PUBLIC SERVICE ELECTRIC & GAS CO.
 HOPE CREEK GENERATING STATION
 UNITS 1 & 2

CROSBY VALVE & GAGE CO. ORDER NO. 10855-M-41(Q)-AC CROSBY F.O. N61264 PREPARED BY KJM 2-20-76 CHECKED BY EES 3-16-76 APPD. 4-1-76		ASME SECT III CL. 3 CROSBY VALVE & GAGE CO. WRENTHAM, MASS. 02793	
DRAWING TITLE VACUUM RELIEF VALVE		DRAWING NO. DS-C-6Q901	
WEIGHT 400 LBS. APPROX SIZE 6X6 STYLE VR ASSEMBLY NO. N60901		REV. H

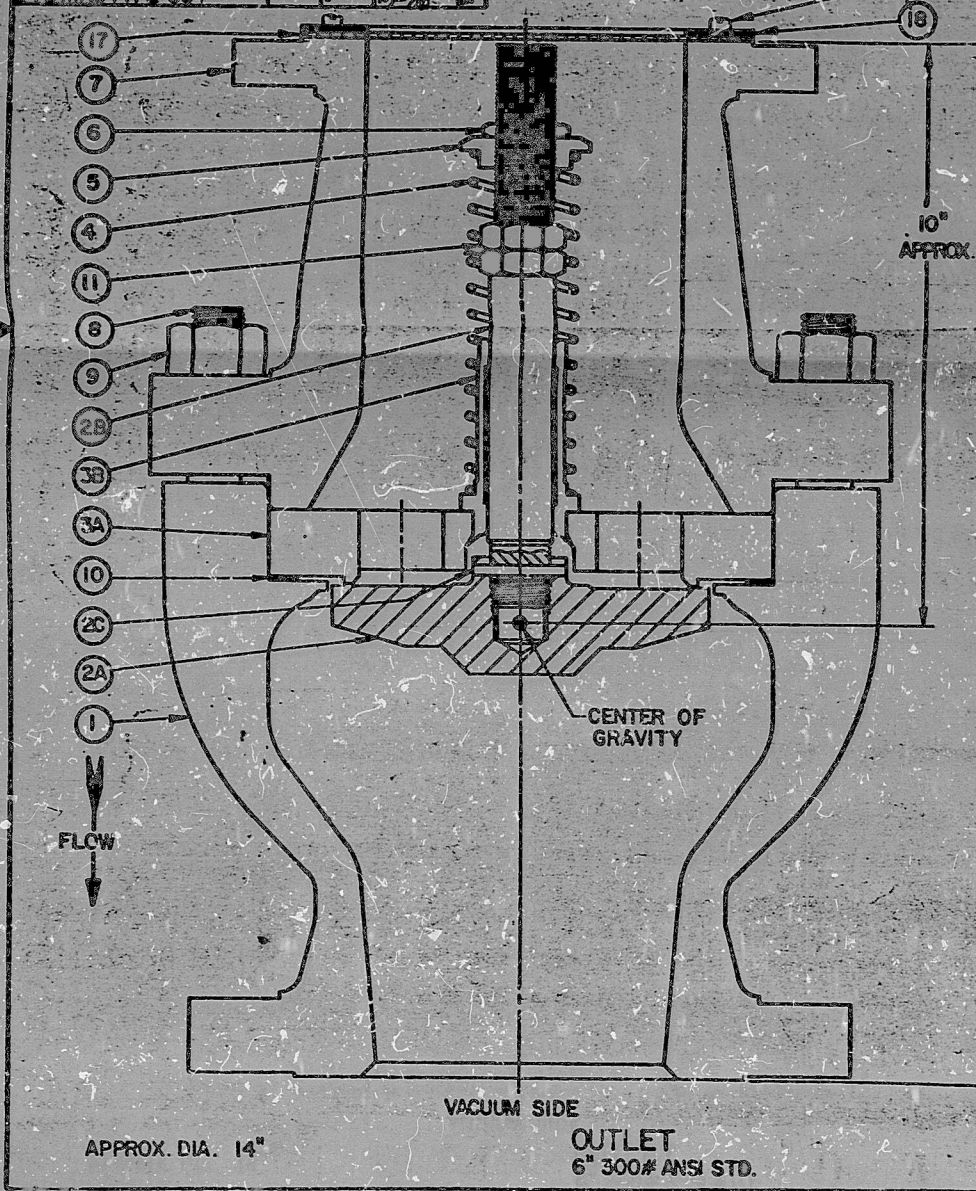
REV	DESCRIPTION	BY	CHK	APPROVED	REV	DESCRIPTION	BY	CHK	APPROVED
	WAS 15-65N-422-65				F	DESIGN PRESS WAS 800 HYDROSTATIC PRESS WAS 750	BCH		
A	ADDED PC NOS 12, 13, 14, 15, 16 - ADDED NOTE 5 & SUB-ASSY WERE - INLET - AIR - OUTLET - N2, INLET TEMP WAS 340 PC NO. 10 - QTY WAS 1 PC NO. 11 WAS RETAINING RING.	KM			G	REVISED TAG NO. CHART	WD		
B	PC NOS 2, 3 WERE CFB, PC NO. 5 WAS 304 LGT. WAS 1 1/4"	KM			H	ADDED PC NOS 17, 18 & 19			
C	PC NOS 2, 3 MAT'L WAS ASME SA351 GR. CFB, PC NO. 10 QTY. WAS 2, REMOVED PC NO. 12.	RB							
D	REDESIGNED	RB							
	PC MAT'L SPEC. WAS TYPE 304	LAL
